## APPEAL SUMMARY

**Status:** Decision Rendered**Appeal ID:** 15802**Project Address:** 1440 NW Overton St**Hearing Date:** 9/13/17**Appellant Name:** Don Vallaster**Case No.:** B-002**Appellant Phone:** 503-228-0311**Appeal Type:** Building**Plans Examiner/Inspector:** Steve Mortensen**Project Type:** commercial**Stories:** 7 **Occupancy:** R-2, S-2, B **Construction Type:** I-A, III-B**Building/Business Name:****Fire Sprinklers:** Yes - NFPA 13 throughout**Appeal Involves:** Erection of a new structure**LUR or Permit Application No.:** 16-287598-LU**Plan Submitted Option:** pdf [File 1]**Proposed use:** multi-family dwelling

## Appeal item 1

PROJECT NAME:  
OVERTON 15

G006

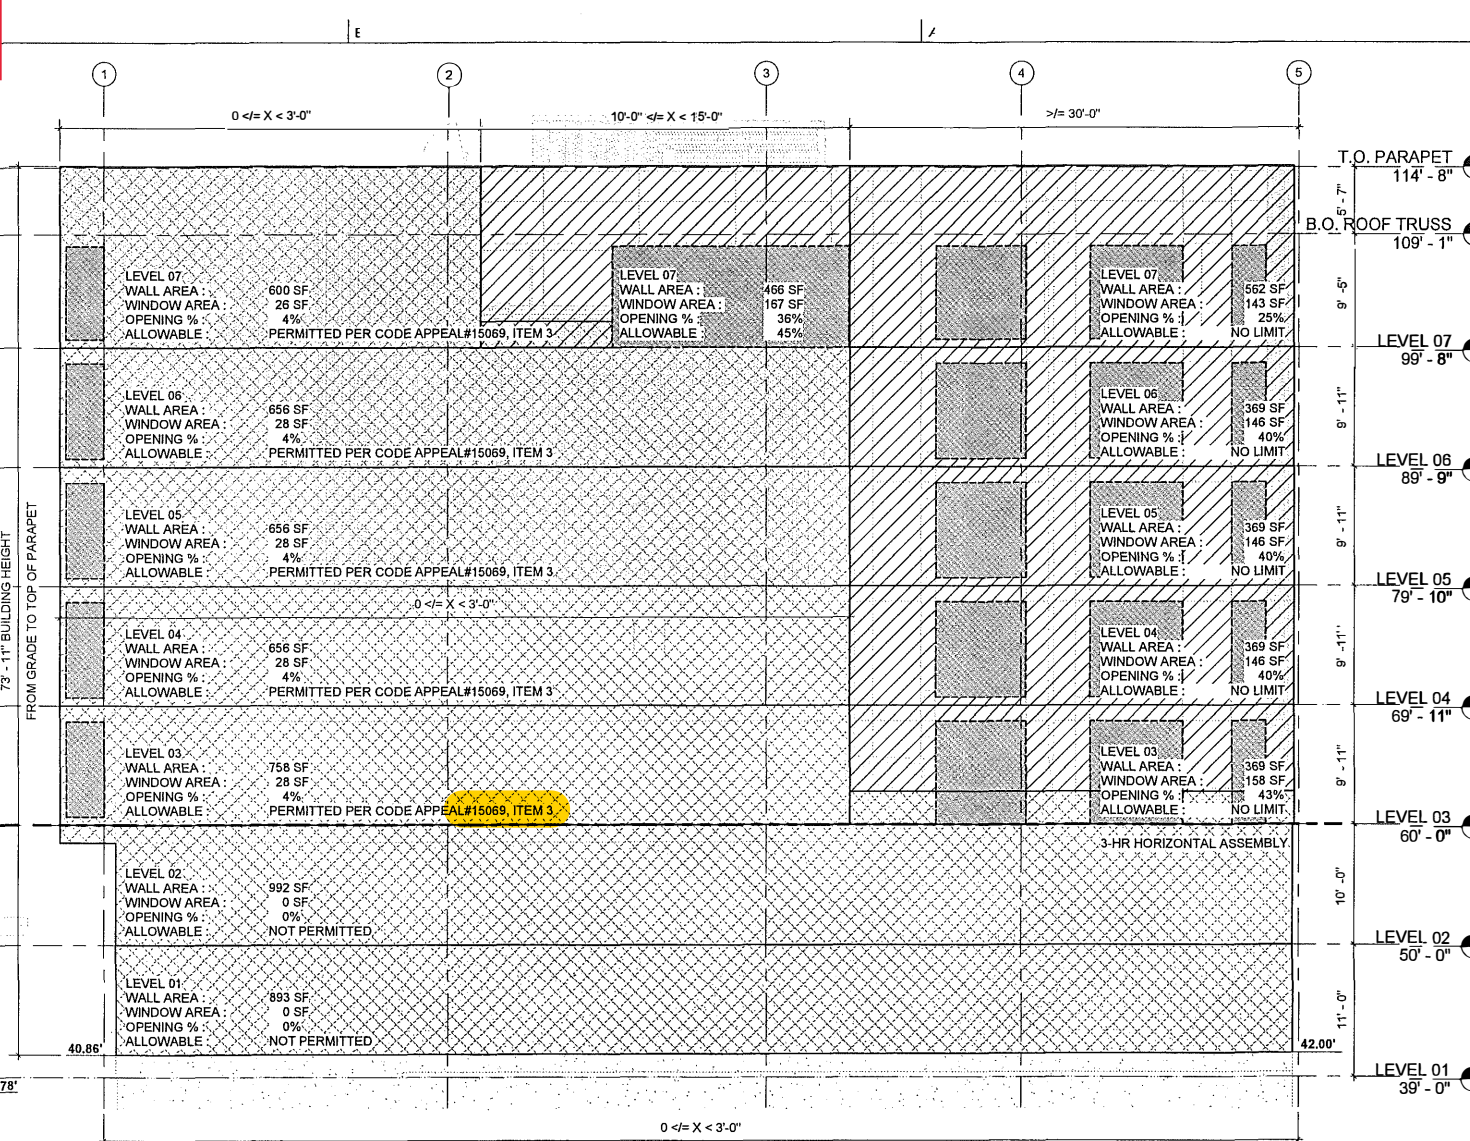
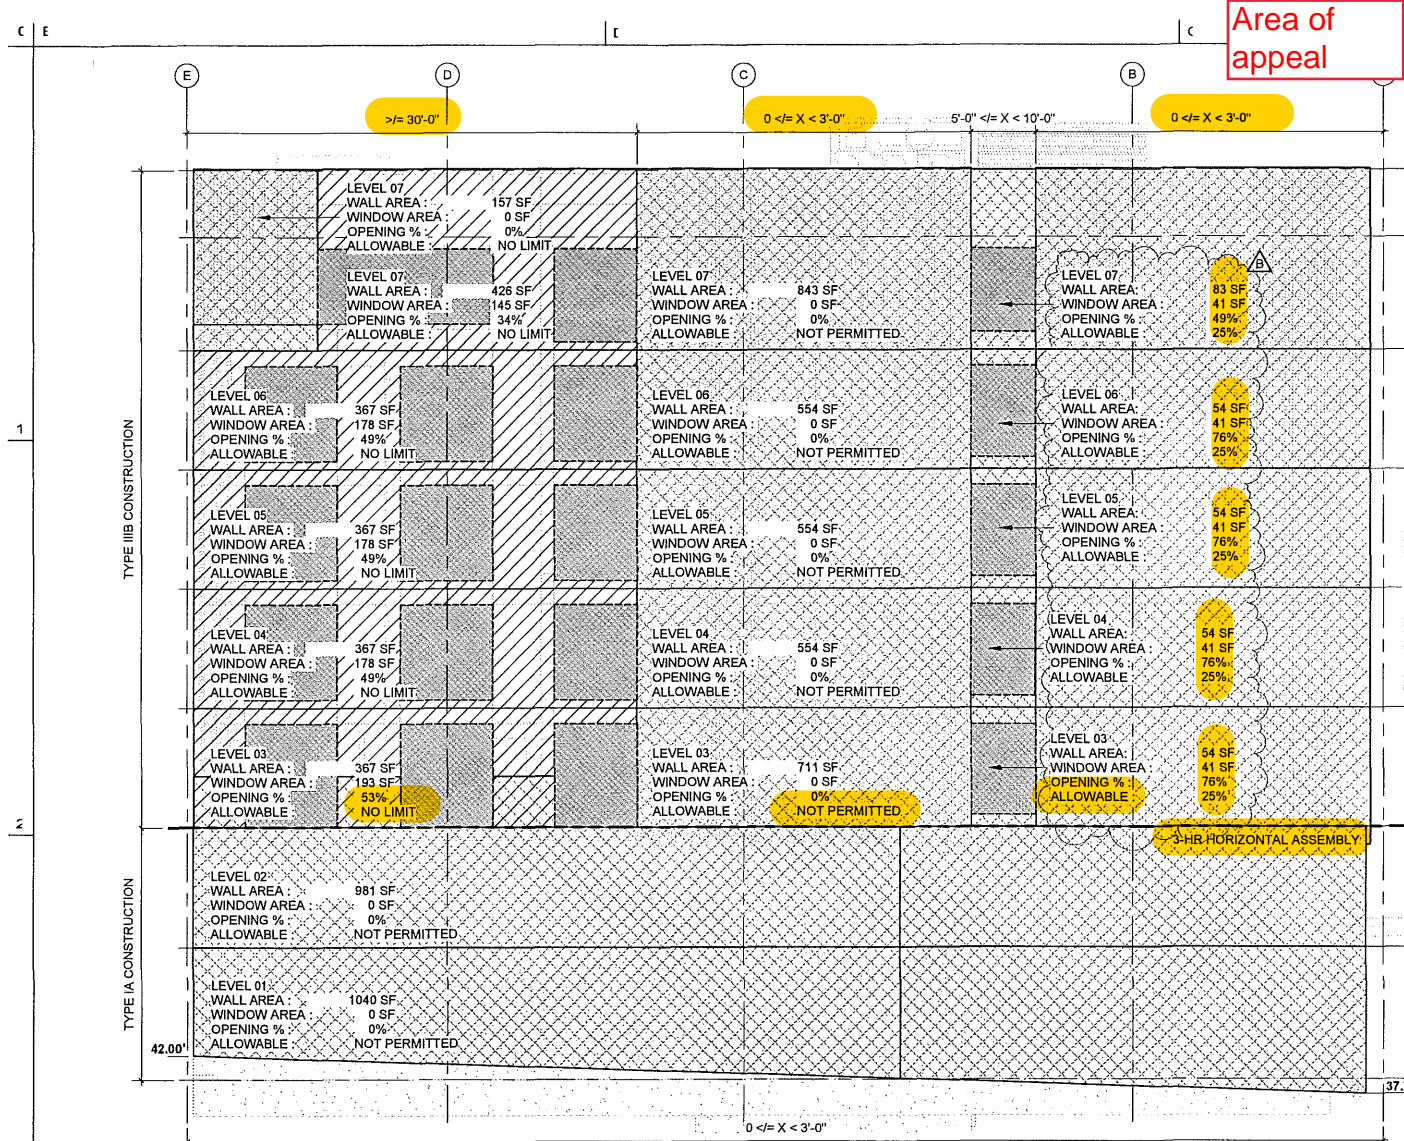
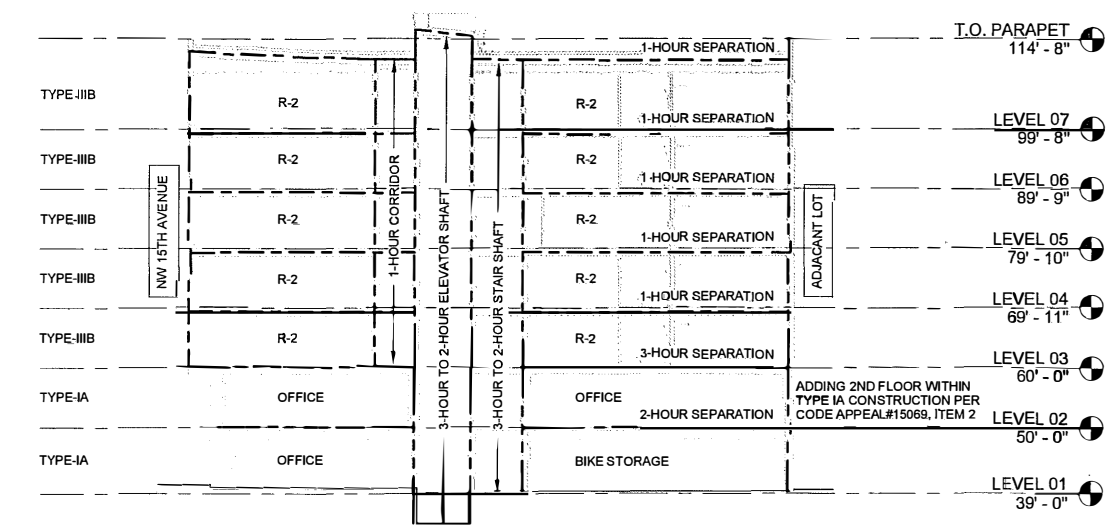
**Proposed Design** The proposed building design includes (5) fixed windows on floors 3 - 7 that are 5'-2" from the east property line. The windows are 5'-6" x 7'-6" each for a total of 205 sq ft in a wall area of 301 sq ft; total window to wall percentage is 68%. The windows will be non-operable aluminum.

The design proposes to protect the window openings from the interior of the building via additional quick-response deluge sprinkler heads centered over of each window opening at a height of no more than 6" above the window head. Windows are to be placed in a 3-hour rated wall.

See attached drawing 1/G006 and 2/G012 for more information.

**Increase of glazing area in fire rated wall with glazing protection provided by additional sprinkler heads:  
Denied. Proposal does not provide equivalent Fire / Life Safety protection.**
